UNITED STATES PATENT AND TRADEMARK OFFICE

10/675,050

Office Action Summary	Application No.	Applicant(s)	
	10/675,050	GERGINTSCHEW, ZENKO	
	Examiner	Art Unit	
	Dharti H. Patel	2836

DETAILED ACTION

FIG. 1
PRIOR ART

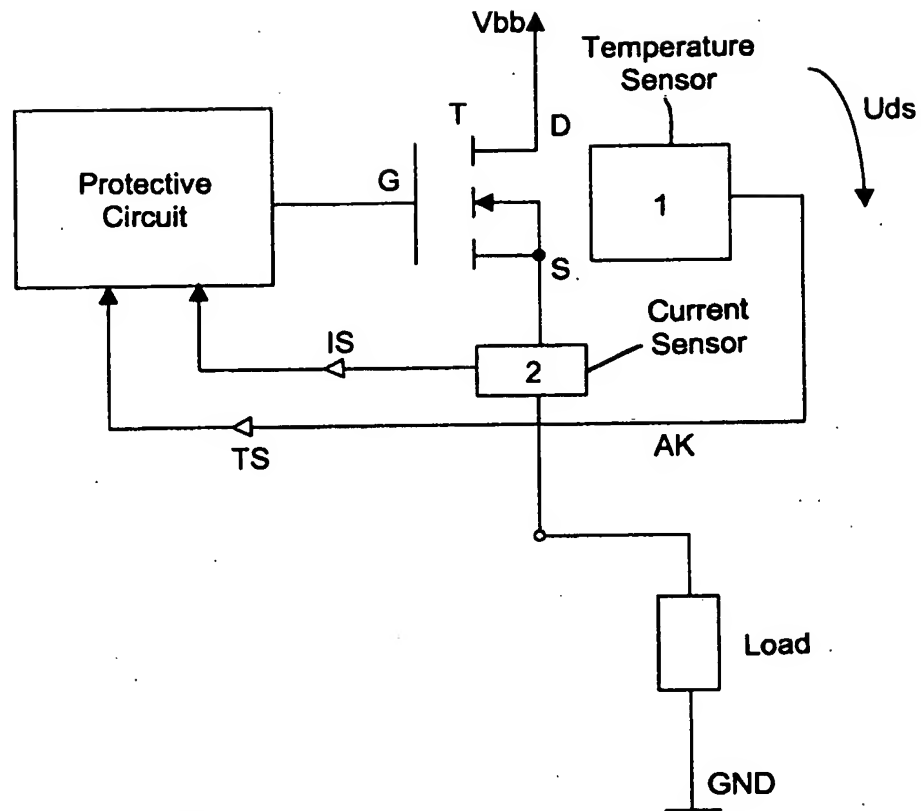
1. Claims 1-4 are rejected under 35 U.S.C. 103(a) as being unpatentable over the acknowledged prior art, in view of Balakrishnan et al., Patent No. 6,781,357. With respect to claim 1, applicant's prior art (Fig. 1 and Fig. 2A) teaches a method for driving a semiconductor switch and circuit configuration with a semiconductor switch. A method comprises a semiconductor switch T having load current limiting (current sensor 2) and thermal protection (temperature sensor 1), the semiconductor switch T switching off upon a predetermined upper temperature T_{so} being exceeded and switching on again when a chip temperature falls below a predetermined lower temperature T_{su} as disclosed in specifications page 11, lines 18-26 and Fig. 2A; operating the semiconductor switch in one of a normal mode (semiconductor switch is on) and a fault mode (semiconductor switch is off); operating the semiconductor switch in the fault mode upon exceeding the predetermined upper temperature T_{so} as disclosed in specifications, page 11, lines 18-20.

3. Claim 6 is rejected under 35 U.S.C. 103(a) as being unpatentable over the acknowledged prior art, in view of Brown, Patent No. 5,757,203. With respect to claim 6, applicant's prior art (Fig. 1) teaches a method for driving a semiconductor switch and circuit configuration with a semiconductor switch. A method comprises a semiconductor switch T having a drive terminal and a load path; a protective circuit connected to the drive terminal of the semiconductor switch T; a temperature sensor 1 disposed in a region of the semiconductor switch T and coupled to the protective circuit, temperature sensor 1 providing a temperature measuring signal TS fed to the protective circuit; and a current measuring configuration 2 coupled to the protective circuit and generating a current measuring signal IS being dependent on a current across the load path of the semiconductor switch as disclosed in Fig. 1.

The following is an examiner's statement of reasons for indicating allowance: With respect to claim 7, applicant's acknowledged prior art (Fig. 1) teaches a method for driving a semiconductor switch and circuit configuration with a semiconductor switch, but does not teach a protective circuit storing first and second overtemperature signals, and, depending on the mode, said protective circuit drives said semiconductor switch into a blocking state according to a comparison of the temperature measuring signal to the first overtemperature signal or according to a comparison of the temperature measuring signal to the second overtemperature signal. This is not anticipated or rendered obvious by the prior art reference.

With respect to claim 8, applicant's acknowledged prior art (Fig. 1) teaches a method for driving a semiconductor switch and circuit configuration with a semiconductor switch, but does not disclose a voltage measuring configuration for detecting a load path voltage of said semiconductor switch and connected to said protective circuit, said voltage measuring configuration providing a voltage measuring signal that is fed to said protective circuit, said protective circuit assumes one of the first and second modes depending on the voltage measuring signal. This is not anticipated or rendered obvious by the prior art reference.

FIG. 2A
PRIOR ARTFIG. 2B
PRIOR ARTFIG. 2C
PRIOR ARTFIG. 2D
PRIOR ART

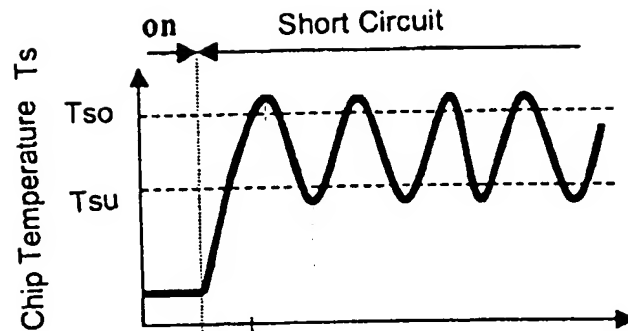
temperature falls below the predetermined lower temperature T_{su} in the normal mode and in the fault mode as disclosed in specifications page 11, lines 18-26 and Fig. 2A.
